# Plantation Acres Improvement District

1701 NW 112<sup>th</sup> Avenue, Plantation, FL 33323  
**AGENDA**  
**October 26, 2023**

**ENGINEER'S STAFF REPORT**  
FOR October 26, 2023 MEETING  
**AGENDA ITEM No.: B1**

## REVIEW COMMENTS

**BOUNDARY SURVEY  
 SKETCH OF SURVEY**

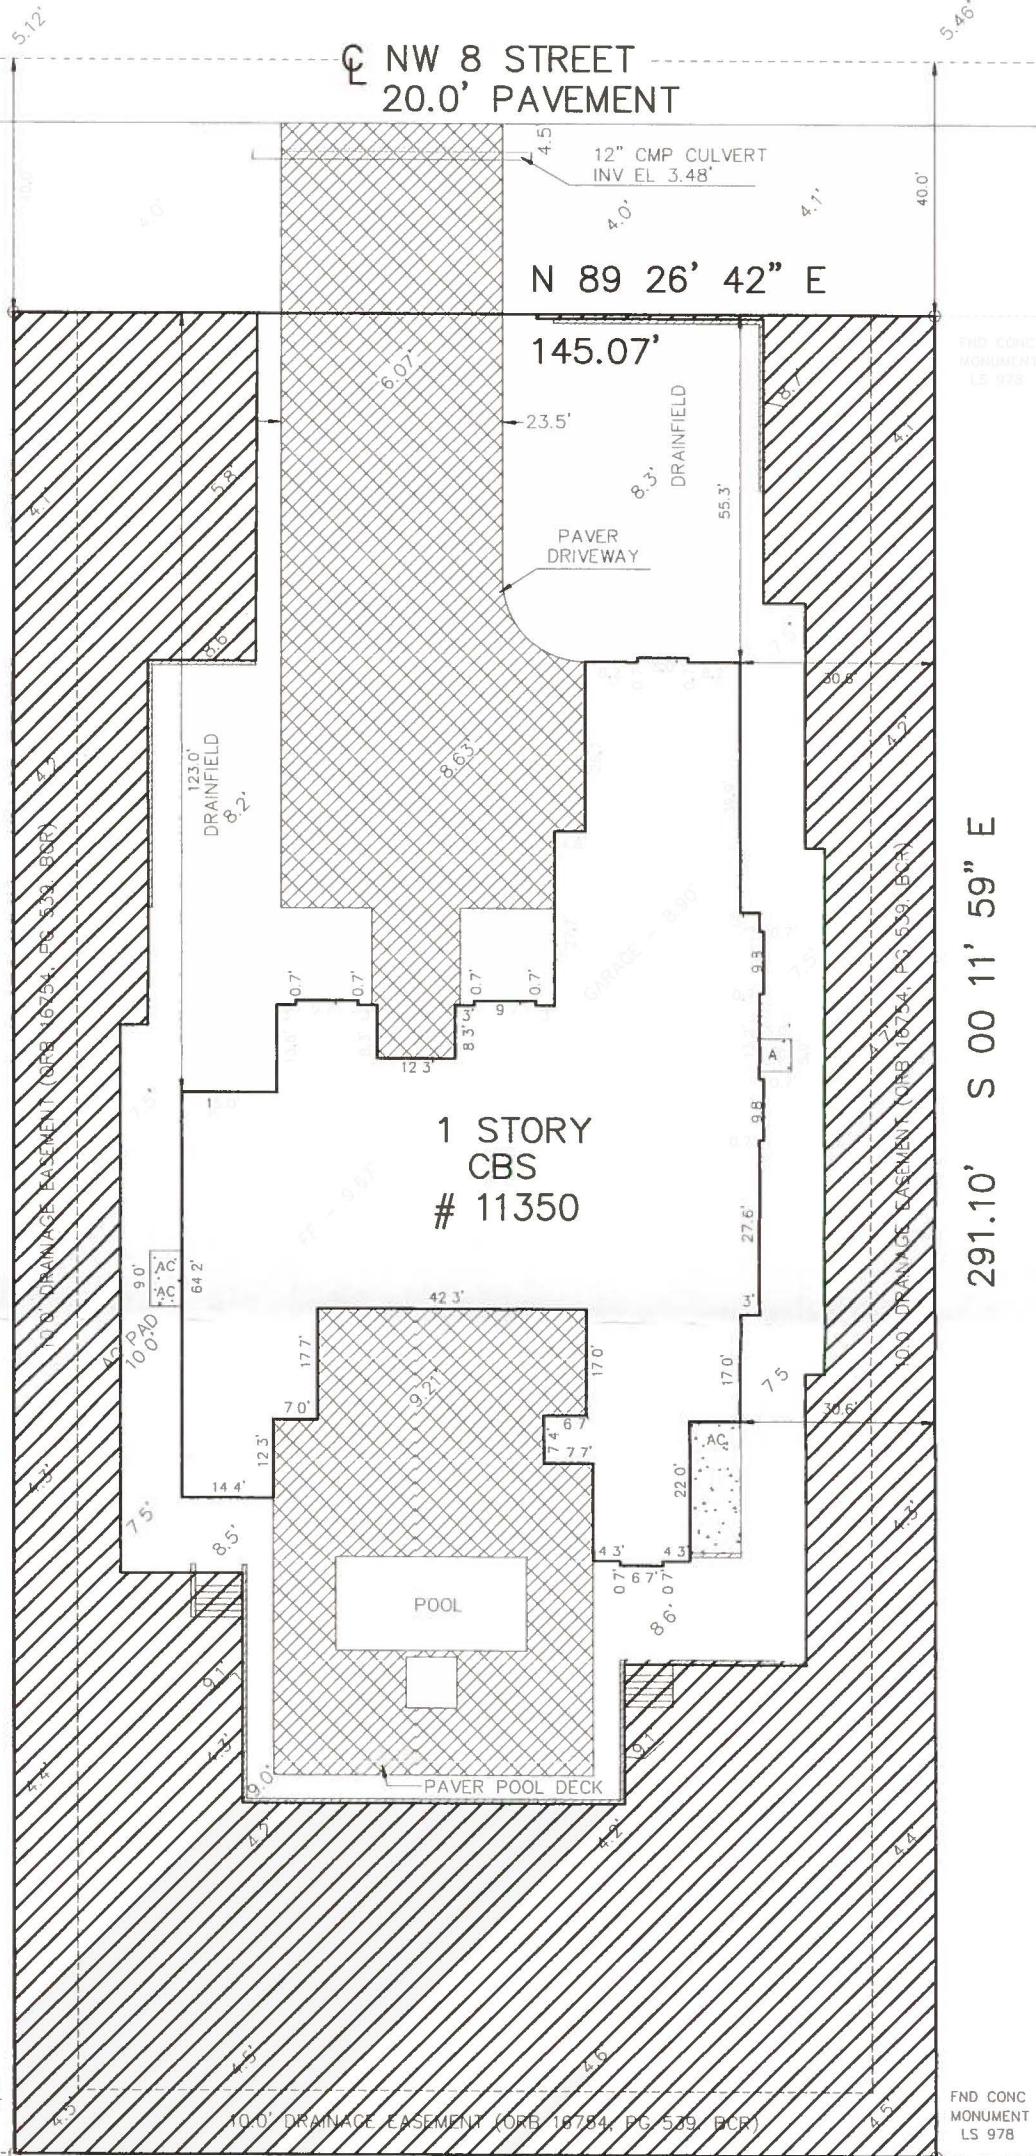
2.	Provide existing and proposed elevations in NAVD-88 datum on site grading plan. Site grading plan shall show the square footage to remain at natural grade (50% at elevation 5.0' NAVD or lower required for this property). Provide proposed natural elevation contour line and lot percentage. See attached sample grading/site plan for your use.	6/27/23	FES

3.	Maximum slopes shall not exceed 4(H):1(V) Add note to plan.	6/27/23	FES	
4.	Add PAID Statement notes to plan. See attached for your use.	6/27/23	FES

5.	Show drainage easements per ORB 16754 PG 539 BCR.	6/27/23	FES	
6.	No walls are allowed in the drainage easements.	6/27/23	FES	
7.	Show all existing structures in the plans. Per photos taken during violation notice, an additional existing structure was found on the SW corner of the lot. This structure has not been approved by PAID.	6/27/23	FES

8.	Provide update topographic survey.	6/27/23	FES	
	Additional comments may be forthcoming upon review of additional information.

PEAK DATA FOR 10 YEAR, 24 HOUR STORM  
NODAL NETWORK

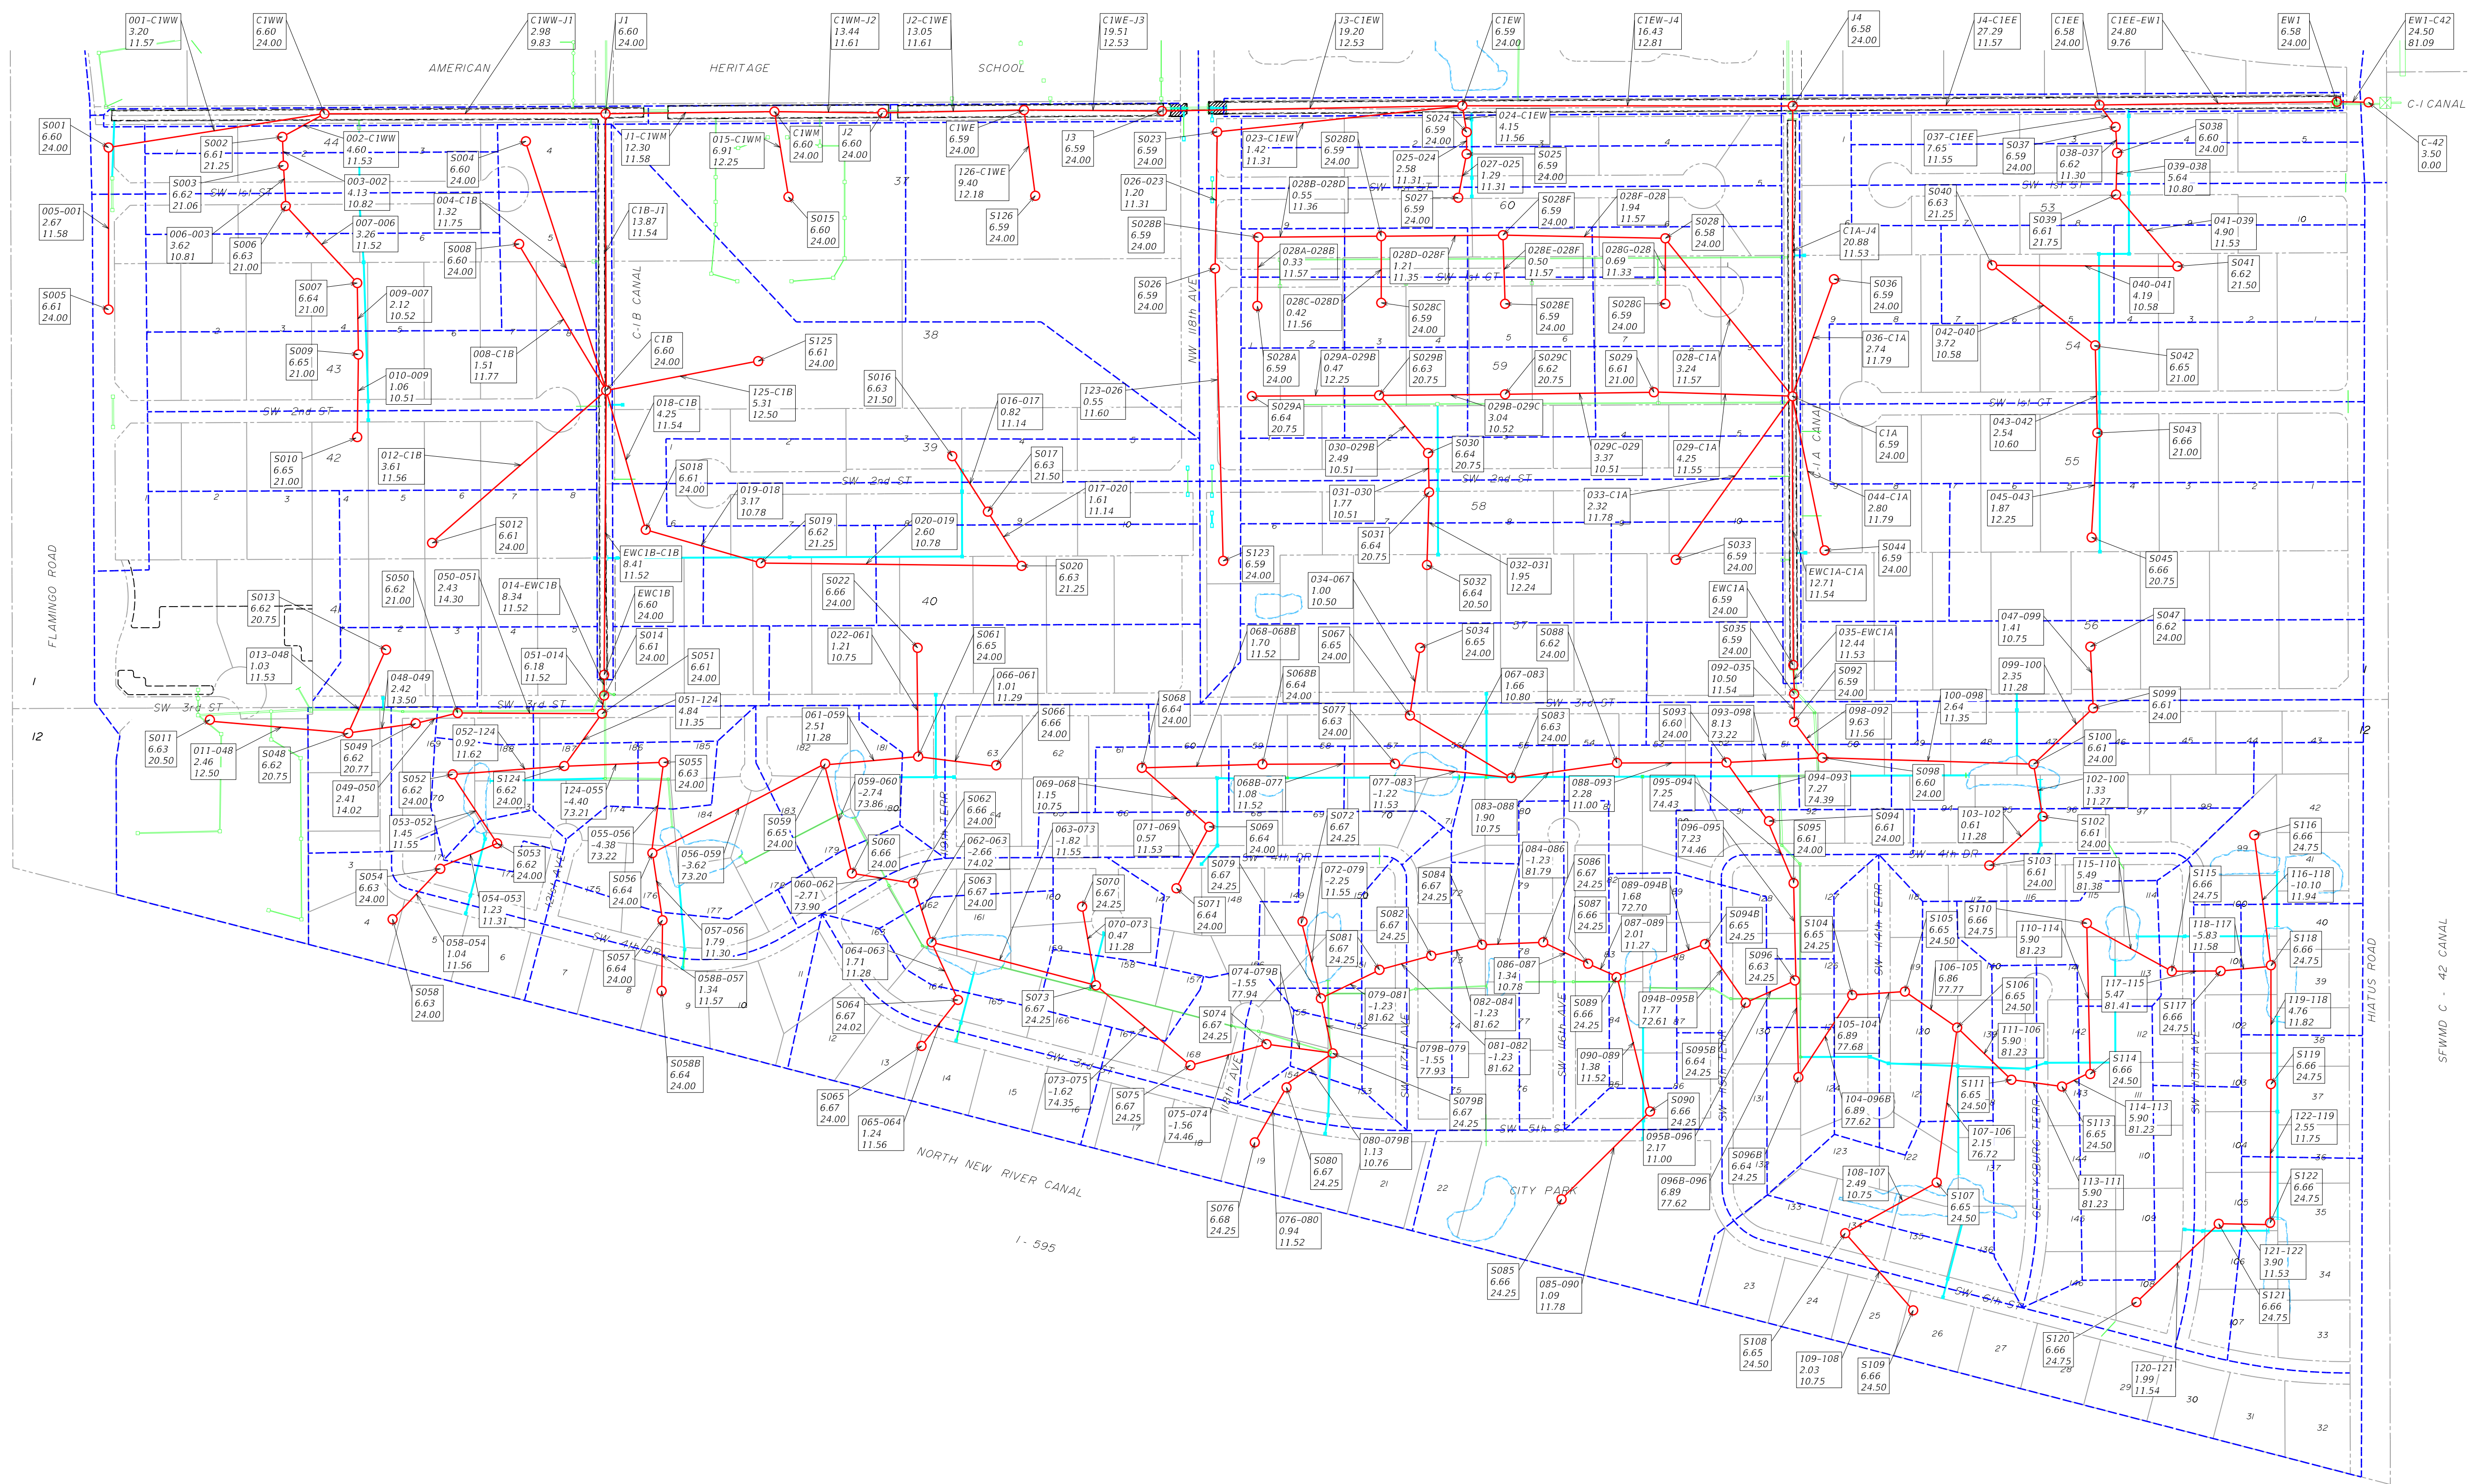
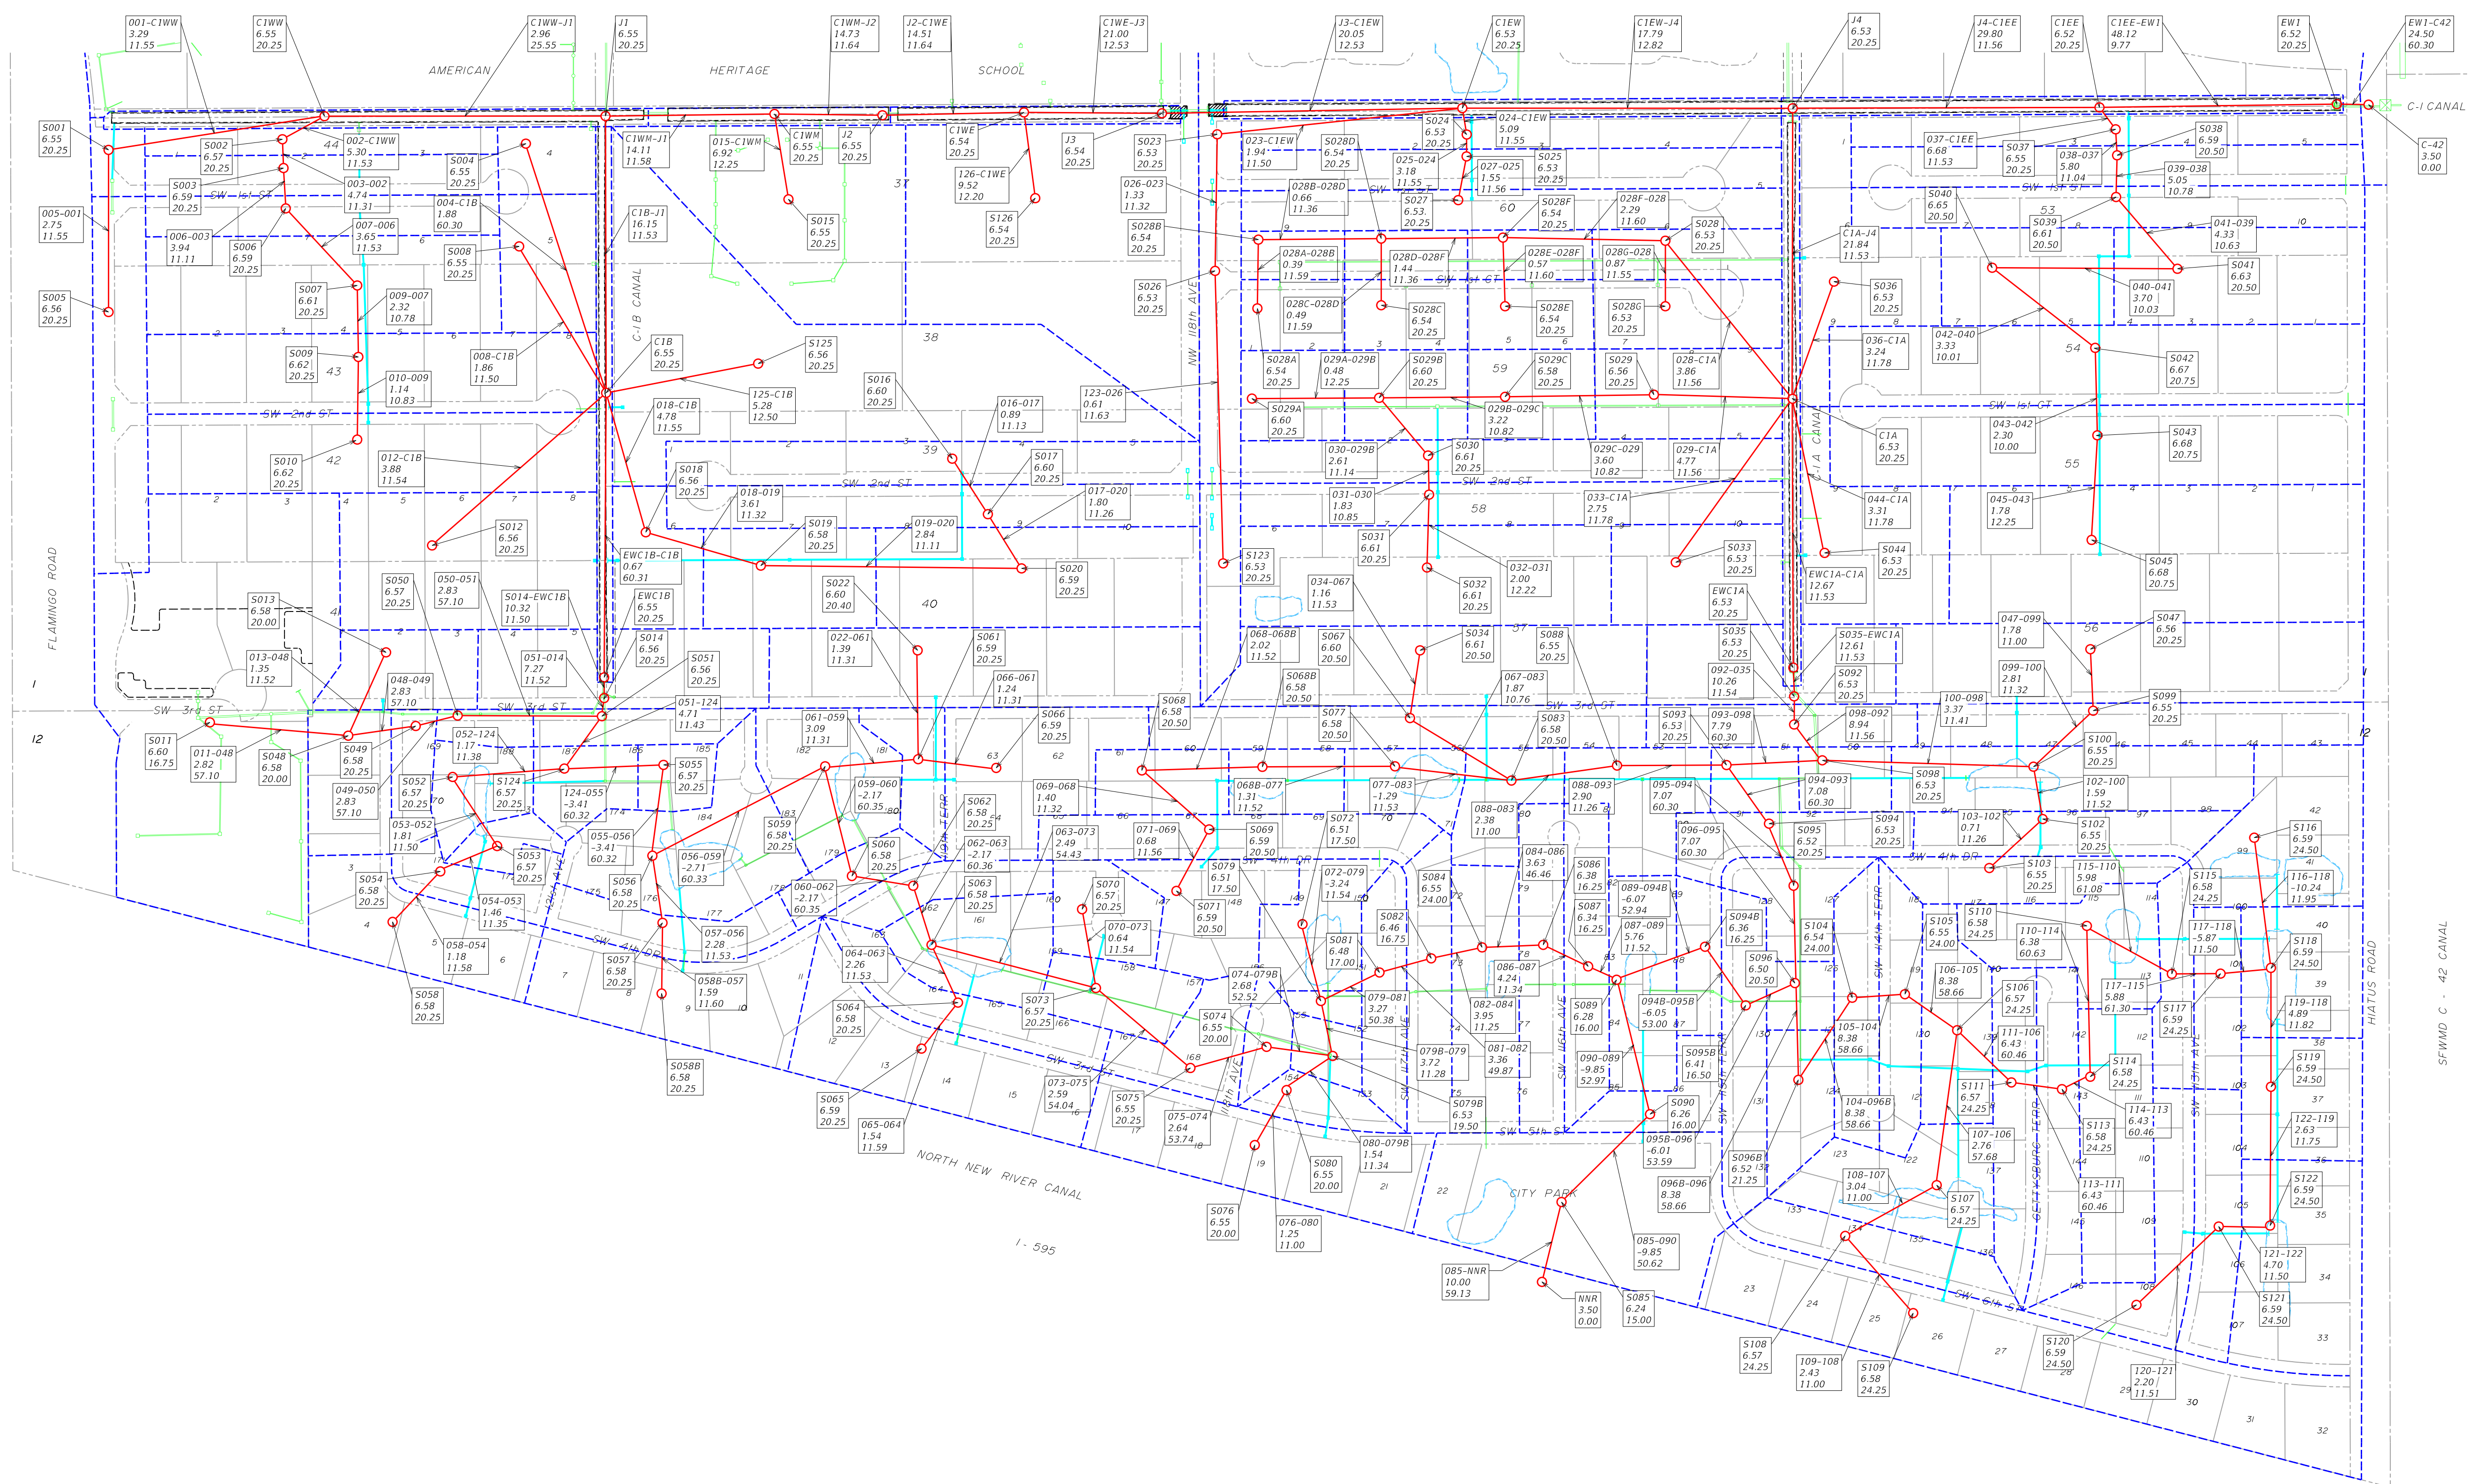
Regarding an auxiliary pump in the South Acres, considerable amount of modeling was done in 2017 on this issue. Attached are the Nodal Networks and Peak Stage Contours for the South Acres with and without a pump. The pump in this scenario was to be permanently located in the City park, where the pond is, and is modeled as pumping directly into the North New River Canal (NNR). Although the modeling is no longer completely relevant because the pump location is un-permissible by SFWMD standards, it does provide useful data for the effectiveness of an auxiliary pump.

2. Findings from the Study:
  - a. After several iterations, the most likely pump rate for the auxiliary pump would be between 5,000 and 10,000 gpm. The rate is based on the ability of the area to deliver water to the pump while

- c. Several alternatives for pump location were considered. What was found was that no location had a significant effect on peak water for ALL of the South Acres. This is due to the vast difference in the uniform rate delivery of rain over the entire area compared to the rate of movement of the rain water toward an outfall. The rate at which the water can be removed is affected by much more than a pump rate. What affects the rate includes the following:

- d. A secondary comparison was made on the flow rates leaving the South Acres. Specifically, the connections to the PAID's A and B Canals. The discharge rates remain theoretically similar. The significance here is that the flow was not reversed due to the auxiliary pump flow. A reversal would indicate that the auxiliary pump was drawing water from north of the South Acres.

- e. The modeling was revisited for this report to address the current focus of reducing the *time* it takes to remove the water from the roads and grassed yards. In general, the model for the auxiliary pump showed a significant theoretical drop in the time to return to similar elevations from the base model. The comparison graphs for the westernmost area in the South Acres and the auxiliary pump in the easternmost pond is attached. Both graphs show the roads being submerged around the 12<sup>th</sup> hour and both show the same peak stage of 6.63 feet (NGVD). However, the time the water level drops to 5.0 ft (approximate swale level) is approximately at the 75<sup>th</sup> hour with no pump and the 61<sup>st</sup> hour with the auxiliary pump. A theoretical drop of 14 hours. It is important to keep in mind the theoretical

4. The conclusion and recommendations for supplementing the drainage in the South Acres with an auxiliary pump:
  - a. The conclusion is that an auxiliary pump would remove additional stormwater from the South Acres and could reduce the time the area is inundated by as much as one-half day.

- b. There is no ideal fixed location for the auxiliary pump, so, the recommendation is that a portable, self powered pump be considered.
  - c. A pump size of 10,000 gpm is recommended, with a conservative operational rate of no less than 5,000 gpm expected. This is a preliminary recommendation that may change after further research into costs, portability, and the pump's intake environment.
